Planning Office for Urban Affairs

Comments from December 4, 2018 BCDC meeting

Comments from January 16, 2019 BCDC Design Committee meeting

41 LaGrange Street

Ground Floor Plan

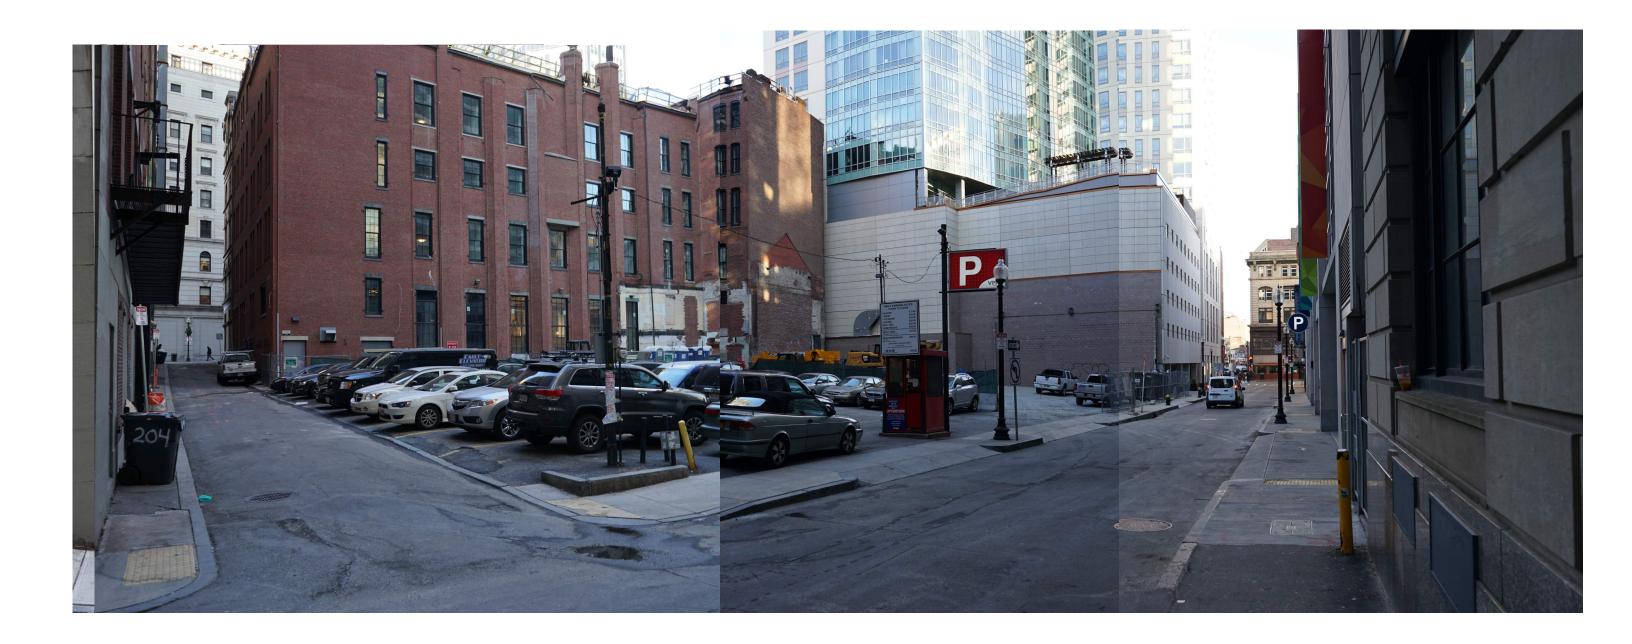
- Concern for recess at ground floor
- Provide more detailed site / sidewalk plan
- Coordinate with 47-55 LaGrange Street design team
- Review color scheme, consider lighter palette

Ground Floor Plan

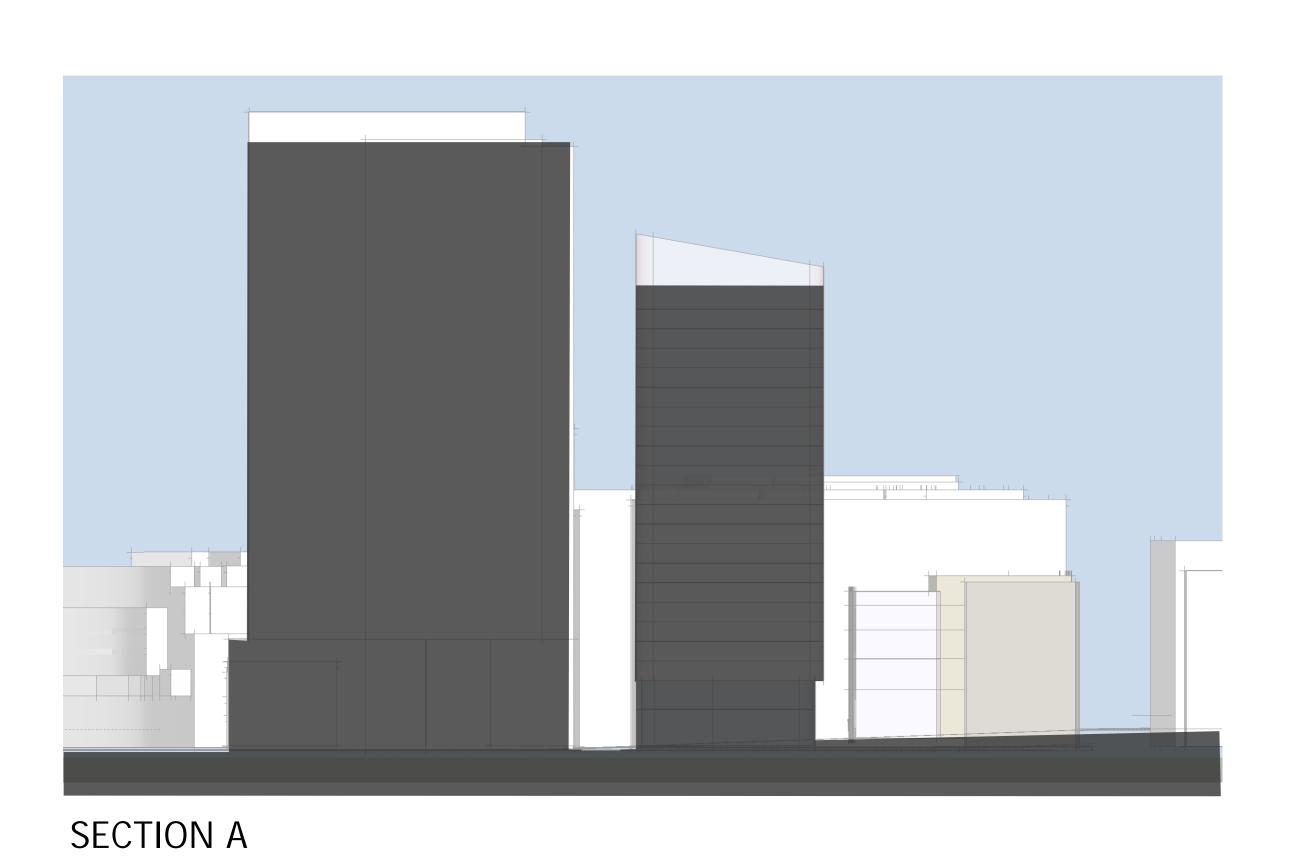
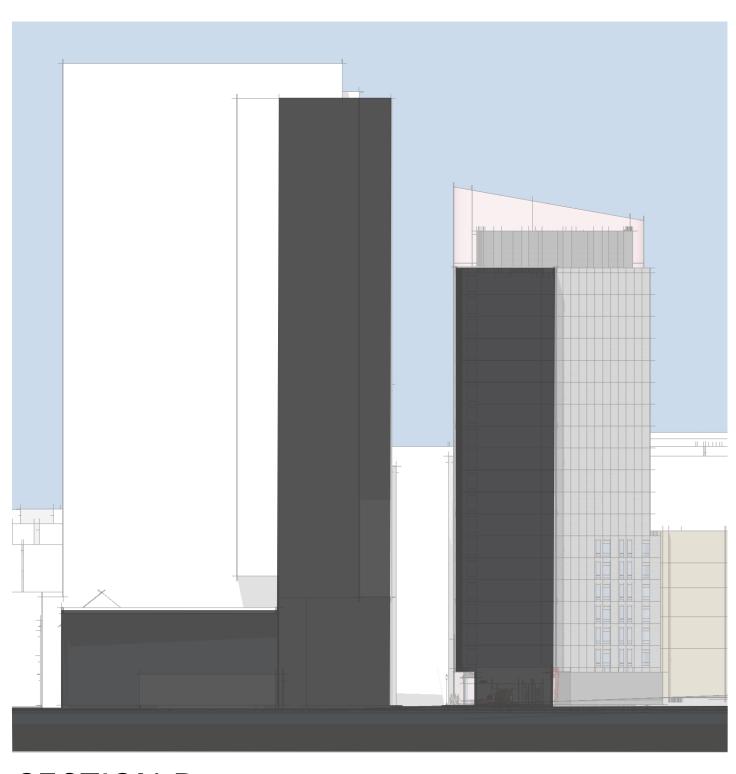
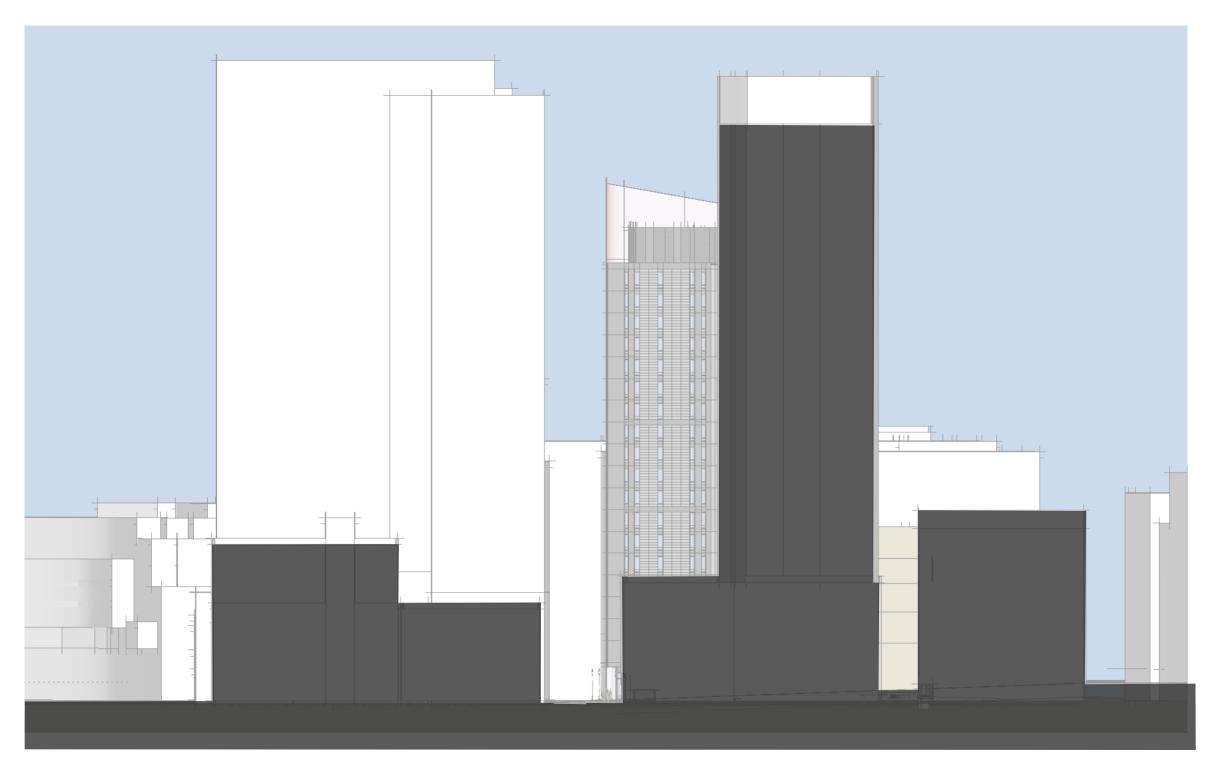
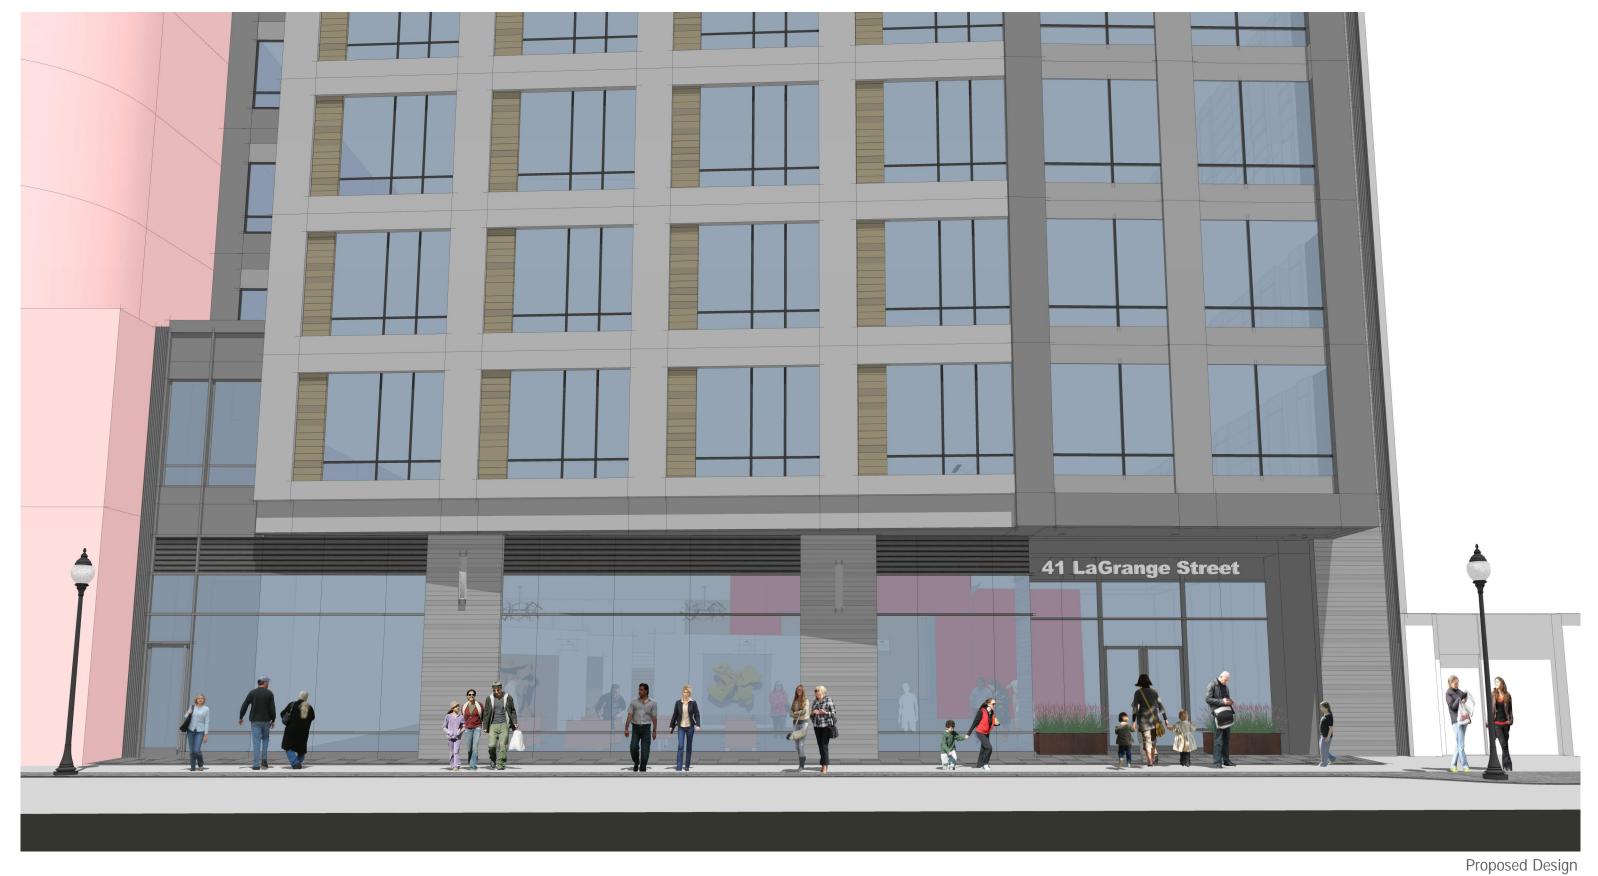
- Provide a physical model
- Need to better understand the pedestrian character of LaGrange Street
- Review relationship of the ground floor facade to the floors above
- Provide sections through LaGrange Street
- Concern for "hiding places" along ground floor facade
- Floor plate is challenging due to maximizing the available area
- Provide materials / textures
